## MASTER DEVELOPMENT PLAN FOR THE BOULDERS AT CANYON SPRINGS (ENCLAVE SUBDIVISION)

MDP # 806-A

Re: The Bolders at Canyon Springs (Enclave) Subdivision

The City Staff Development Review Committee has reviewed The Bolders at Canyon Springs (Enclave) Subdivision Master Development Plan M.D.P. # 806A. Please find enclosed a signed copy for your files. Your plan was accepted, however please note the following:

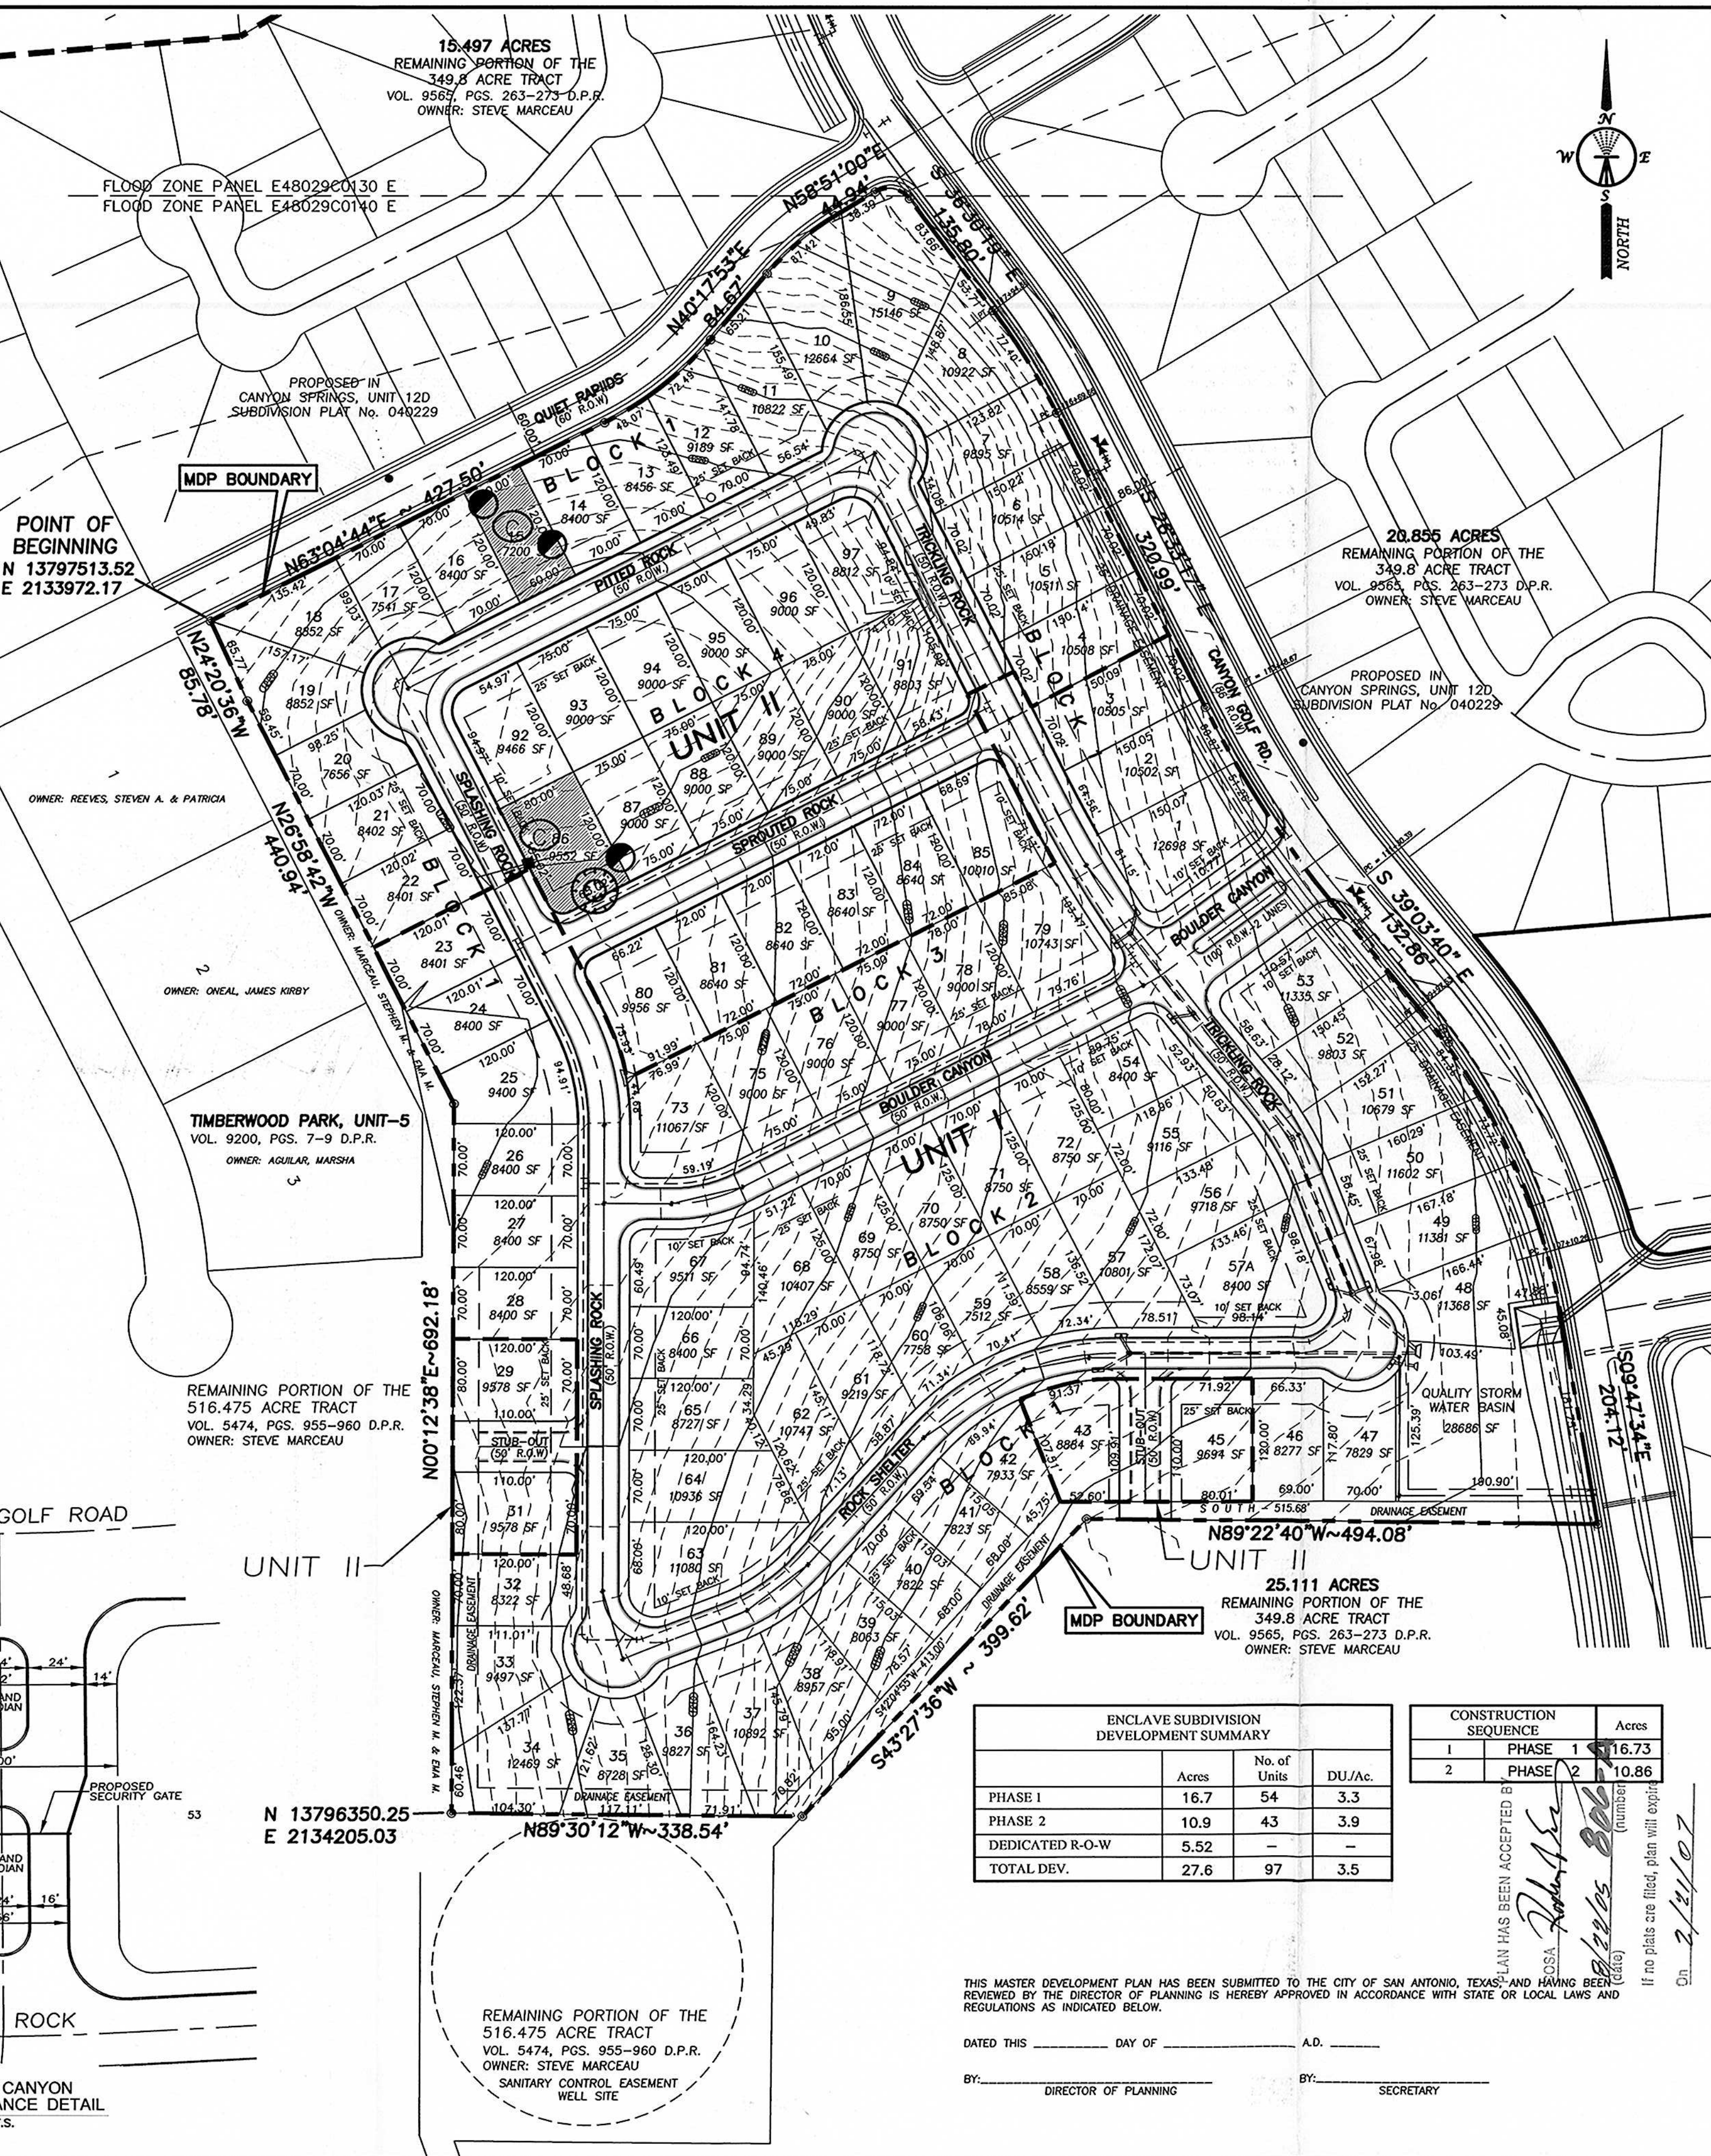
- In consideration of public safety and convenience, excessive grades by reason of topography should be avoided in street layouts and arrangements.
- The acceptance of this Master Development Plan # 806A is confined to the boundary limits of the site. Any projection(s) of future roadways outside the boundaries does not infer any set alignment of future roadways. All major arterials and streets shall follow all regulations.

- Storm Water Engineering will require the following items at the time of platting:
  1. There is a high probability that the revised MDP that includes street stub-outs will change the direction of drainage and subsequently the drainage discharge points.

2. It appears an underground system is proposed to accommodate the direction of water due to the street stub-outs.
  3. Given the steep slopes (terrain) it will be difficult to design adequate "sump" condition inlets to "pick-up" the storm water. The possibility of additional underground storm water may be required.

- Roadways within enclaves and gated communities are not currently subject to requirements of the Bicycle Master Plan. However, if the roadways are ever to be turned over to the City, they will only be accepted if the roadways contain the required bicycle facilities as outlined within the Bicycle Master Plan
